APPLICATION NO.	FILING DATE	FIRST NAMED INVENTOR	ATTORNEY DOCKET NO.	CONFIRMATION NO.	
10/674,739	09/30/2003	William T. Ball	P06474US2 3981		
34082	7590 06/09/2006		EXAMINER		
ZARLEY LAW FIRM P.L.C.			FETSUGA, ROBERT M		
CAPITAL SQ 400 LOCUST			ART UNIT	PAPER NUMBER	
DES MOINES, IA 50309-2350			3751

Advisory Action Before the Filing of an Appeal Brief

CAP FOR FALING A BATHTUB OVERFLOW FOR

Fig. 1A

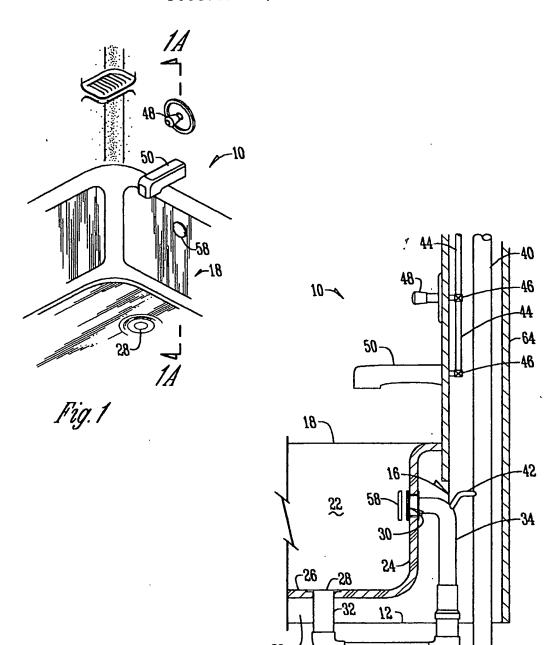
U.S. Patent and Trademark Office PTOL-303 (Rev. 7-05) Continuation of 3. NOTE: changing originally filed "solid stub" to --hollow stub tube-- is new matter.

Continuation of 11. does NOT place the application in condition for allowance because: Pipe 42 not present in 10/247,247 (copy of Fig. 1A attached hereto). Term 'hollow stub tube" not present in instant application at filing.
